DEPARTMENT OF GENERAL SERVICES
BUREAU OF CAPITAL PROJECT DESIGN MANAGEMENT
1800 HERR STREET
HARRISBURG, PENNSYLVANIA

ADDENDUM NO. 10

PROJECT NO. DGS C-1576-0010 PHASE 001
PROJECT TITLE - SCI Frackville - Electrical Upgrades

DRIVING No. C3.1

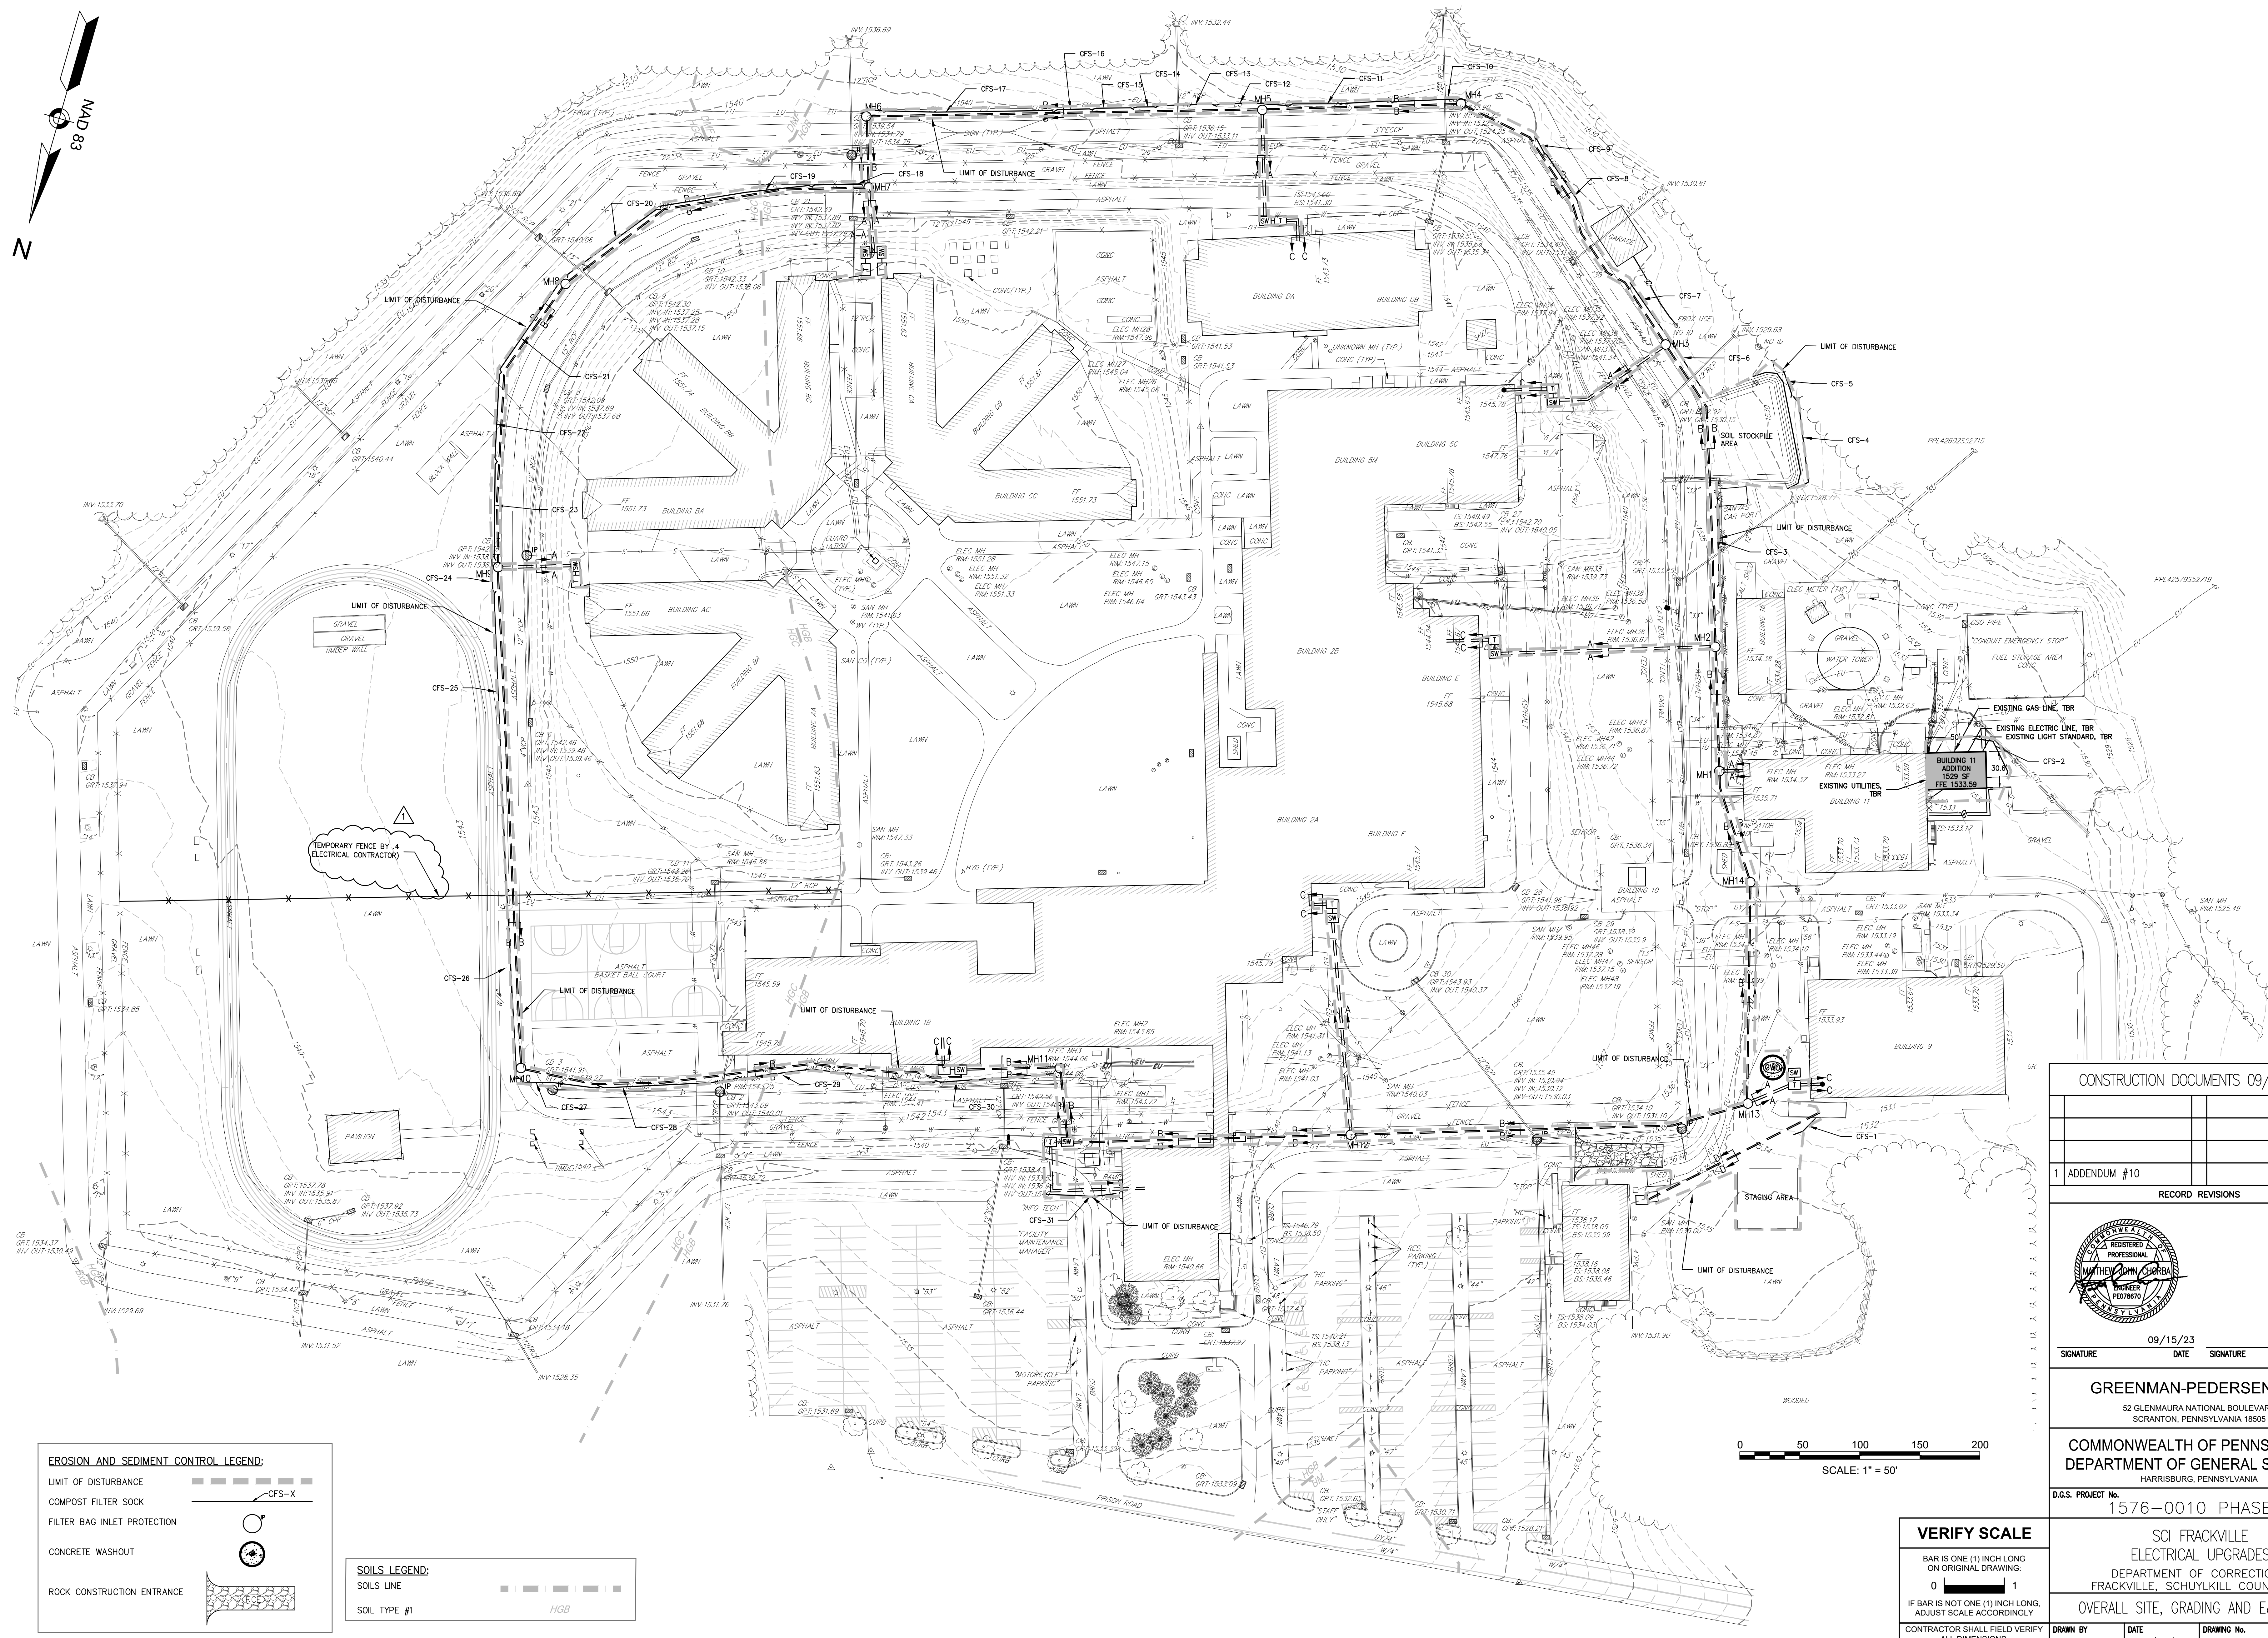
Item 1 - C3.1 – Change note at temporary fence to “TEMPORARY FENCE BY .4 ELECTRICAL CONTRACTOR”.

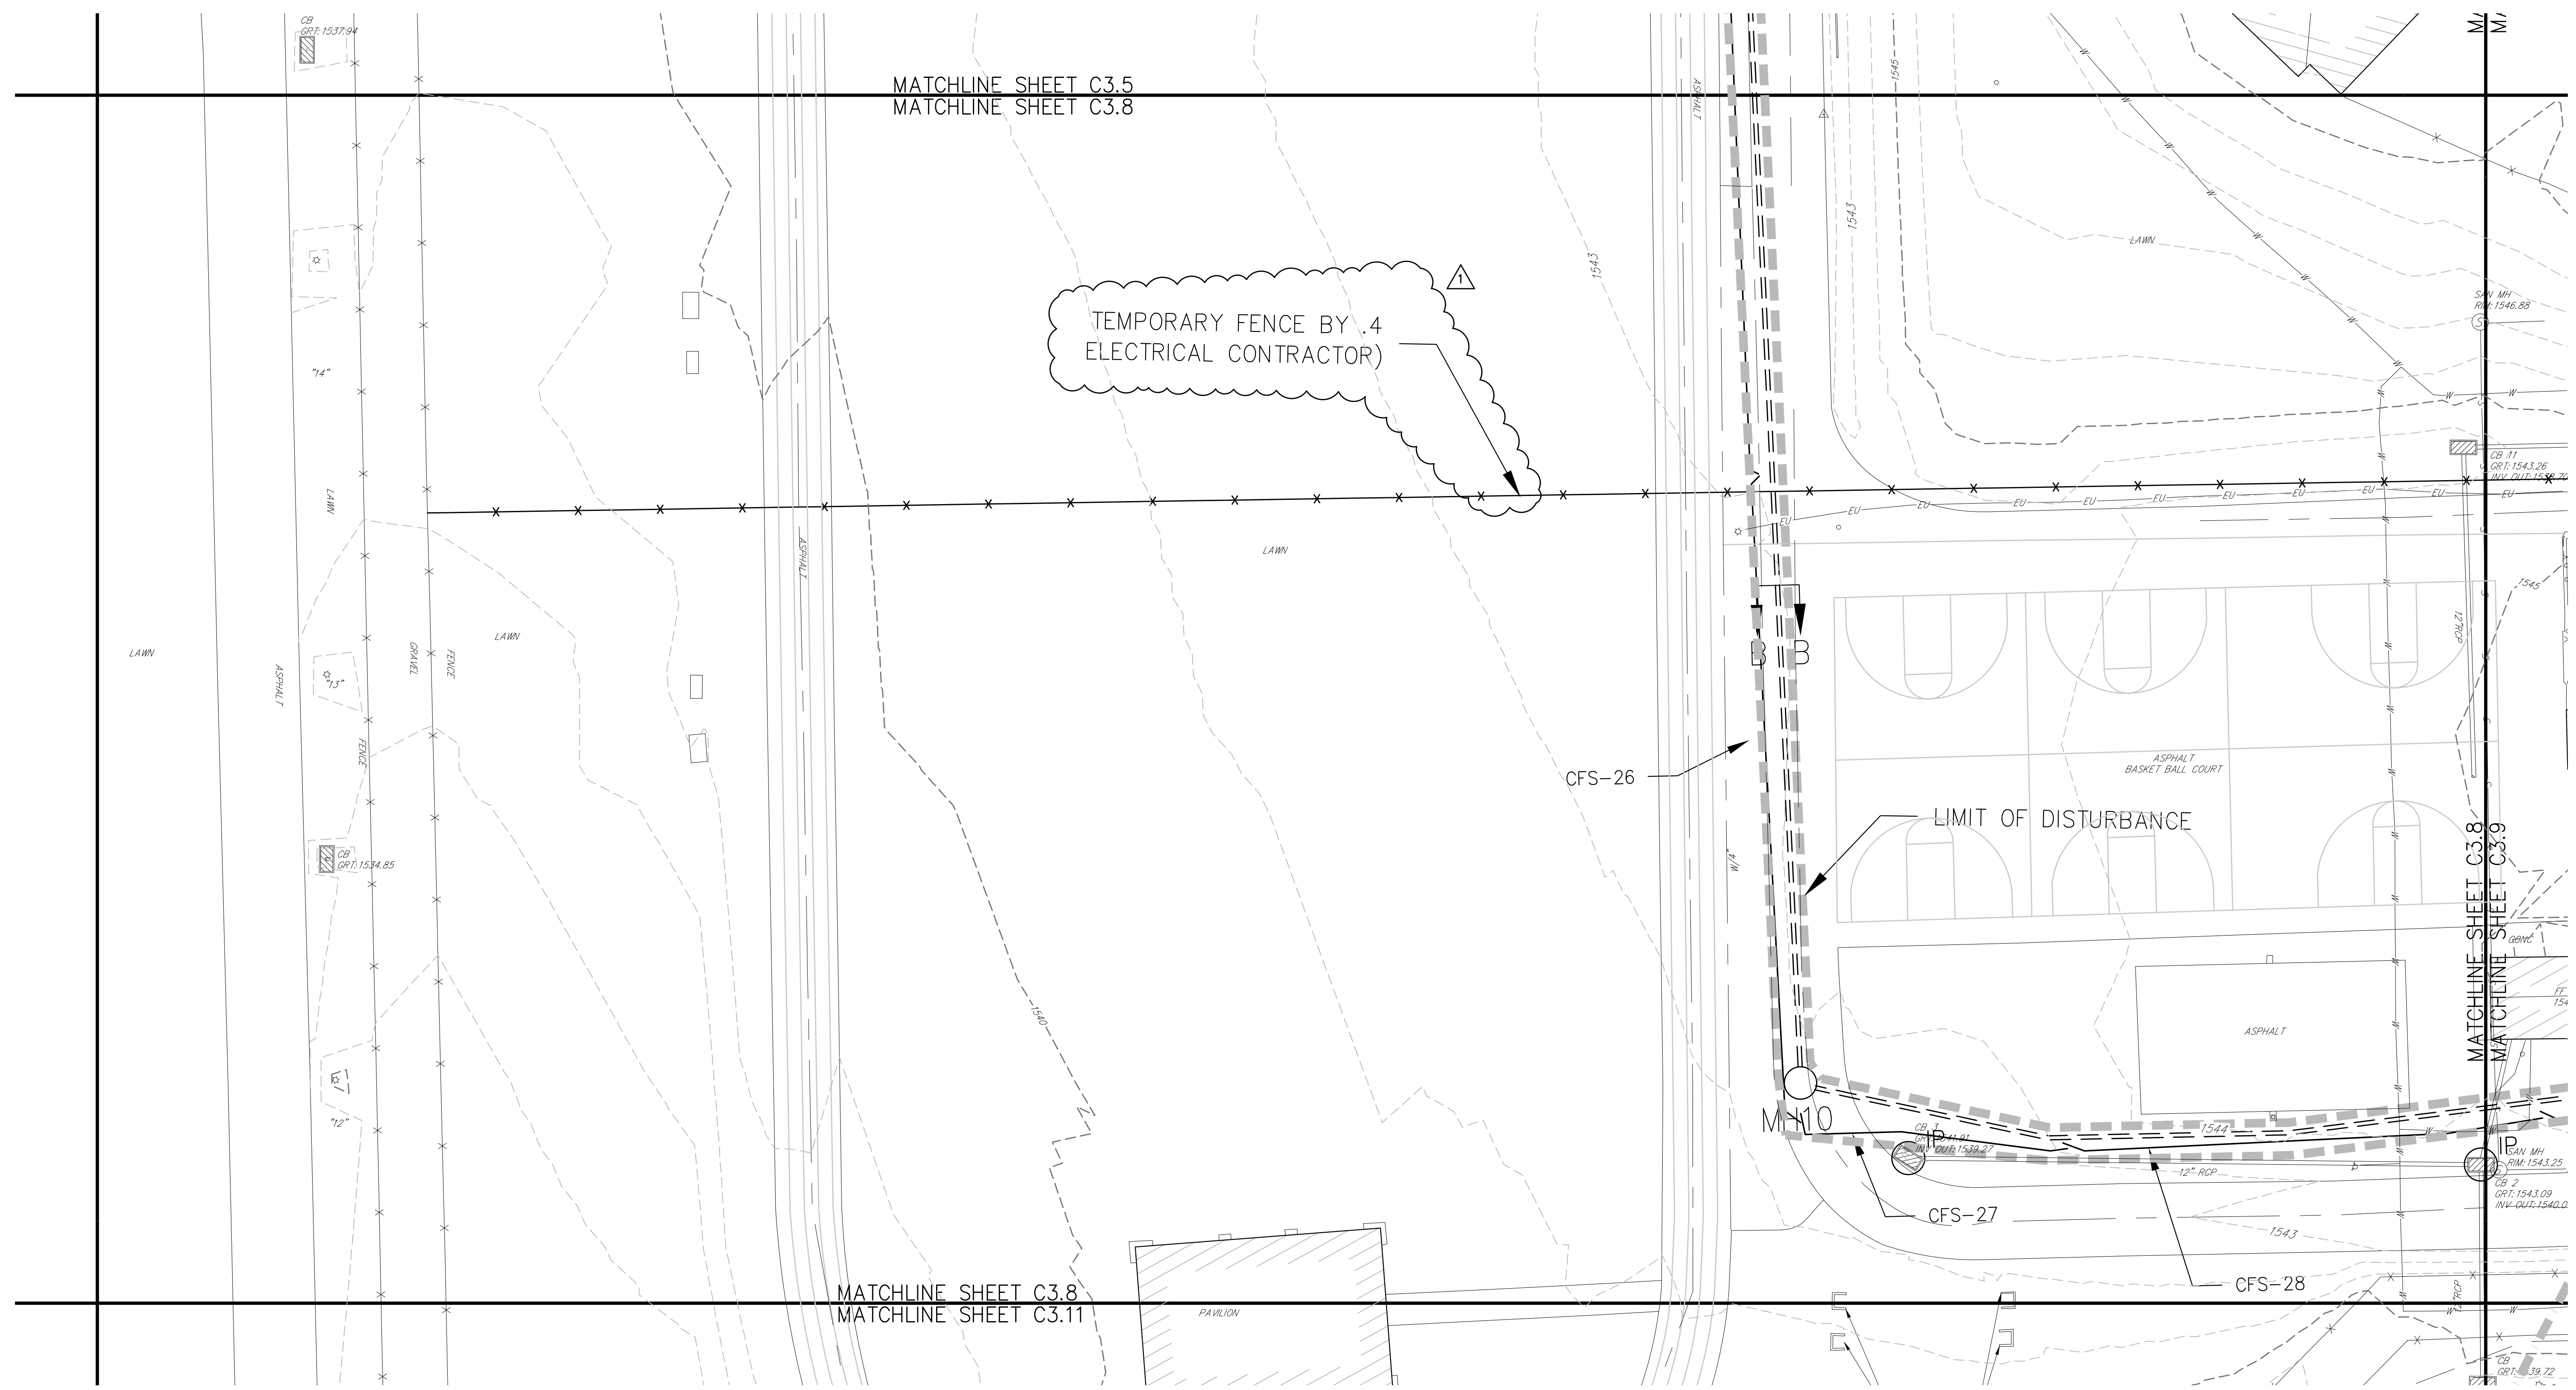
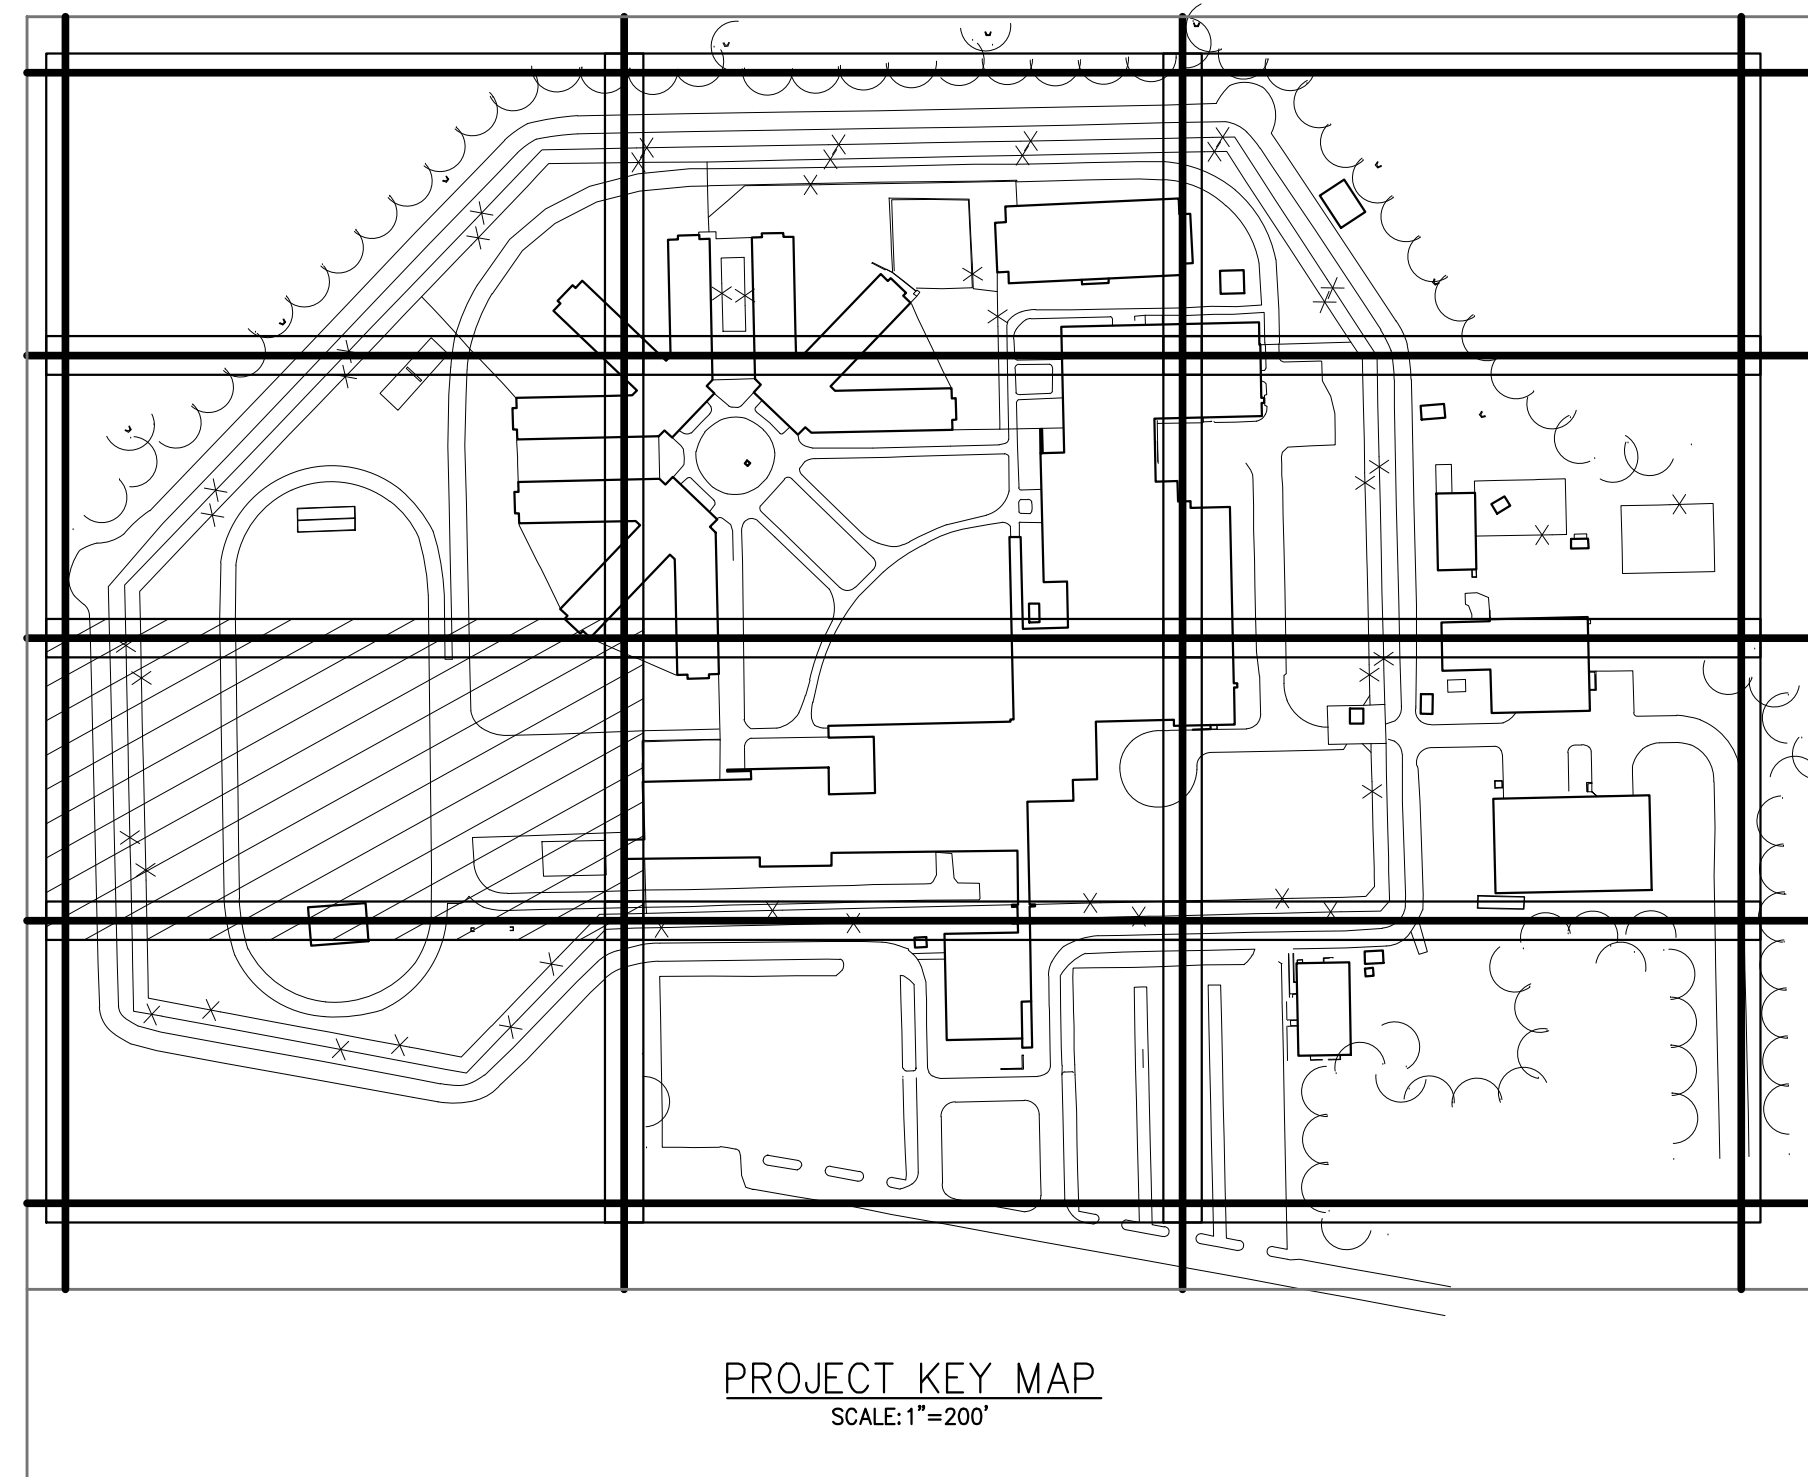
Item 2 - C3.8 – Change note at temporary fence to “TEMPORARY FENCE BY .4 ELECTRICAL CONTRACTOR”.
